INITIAL FIRE SAFETY INSPECTION REPORT

Soorty Textiles (BD) Ltd. (Extension-2)

RSC ID: 25844

Date: 24-Dec-2024

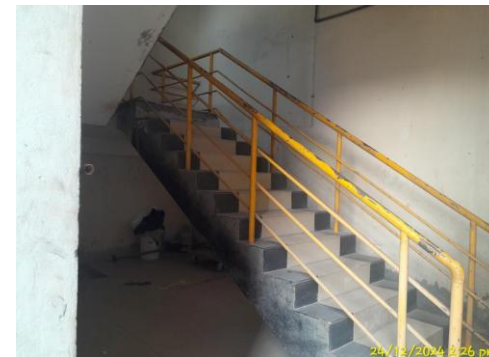
F-6	Means of Egress	<p>Both side handrail was not provided for exit stairs.</p> <p>Location: Production Building</p>	<p>Provide handrails on both sides of the exit stairs & ramps. New handrails shall have a minimum height of 865 mm (34 in.) and a maximum height of 965 mm (38 in.) as measured from the leading edge of the tread. Intermediate handrails shall be provided when the stair width exceeds 2.2 m (87 in.).</p>	Within 1 month
		 <p>24/12/2024 1:30 pm</p>	 <p>24/12/2024 1:35 pm</p>
